RE: Draft Permit to Construct
Owens Corning Insulating Systems – Joplin (ID #097-0176)
Project No. 2015-05-005

A draft of the Permit to Construct for Owens Corning Insulating Systems (OCIS) in Joplin was placed on public notice March 6, 2016 by the Missouri Department of Natural Resources; Air Pollution Control Program (MDNR). The United States Environmental Protection Agency, Region 7 (EPA) has reviewed this draft construction permit and provides the following comments.

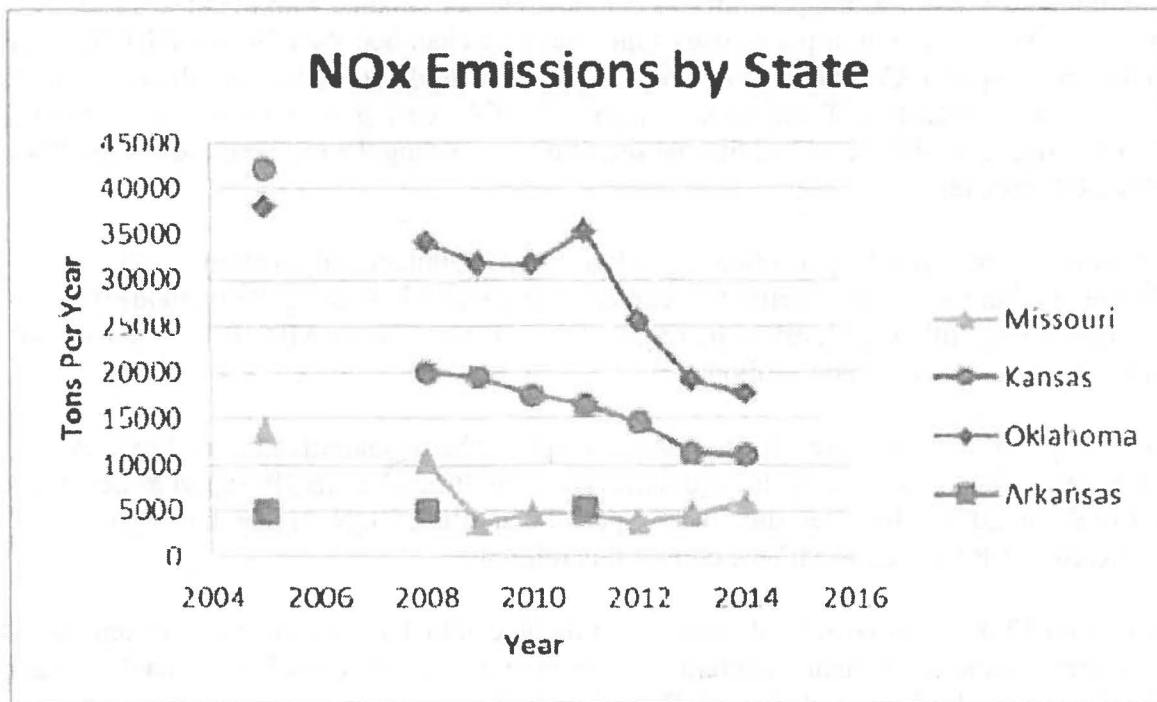
Special Condition 12. B. says the mix building emission points are summarized on page 43 of 106 of the PSD construction permit application addendum, *Figure A-2.2 Process Flow Diagram*. However, the PSD permit application addendum available for public review only has 98 pages and there is no *Figure A-2.2 Process Flow Diagram*. EPA recommends MDNR provide a table of the mix building emission points and relative information. EPA also recommends MDNR provide a OCIS mineral wool manufacturing process flow diagram to aid in the public review of this draft PSD permit.

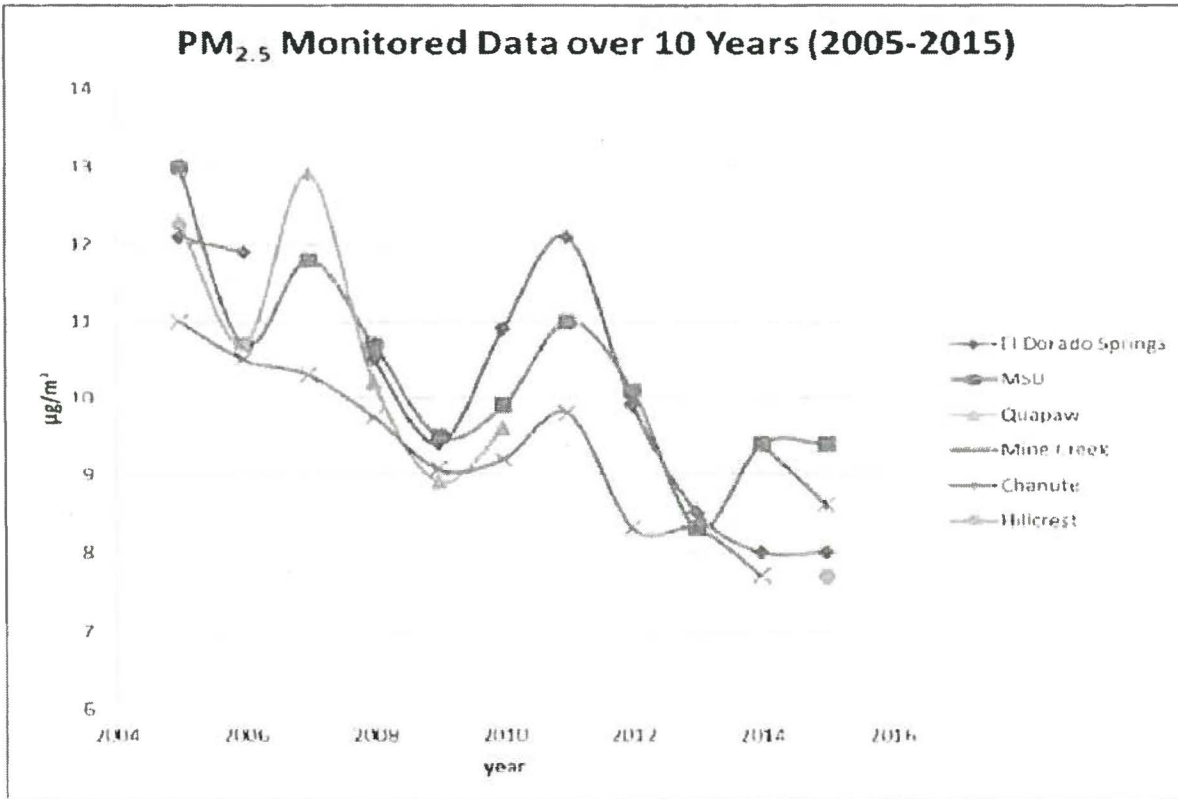
19) MDNR provided a qualitative analysis for impacts of secondary PM2.5 from Owens Corning precursor emissions. In its analysis MDNR looked at trends in regional emissions inventories and regional monitors that measure PM2.5. In its analysis of the National Emissions Inventory, MDNR plots "Facility wide totals of NOx, SOx and PM25 were pulled and combined to get a total amount of emissions per year for each state."

It is not clear what exactly the emissions data that make up these graphs. For example, are all mobile, area, and point sources included? Is it the statewide inventory, or a summation of a few counties from each state located near the new Owens Corning facility?

Also, the likely impacts of year-to-year variability in meteorology is apparent in the graph of monitor trends of PM_{2.5}. The overall trend is downward, but the spikes in 2007 and 2011 are likely due meteorological phenomena. Drawing conclusions from emission trends to monitored concentrations should be done with caution without an attempt to tease out the variability of meteorology.
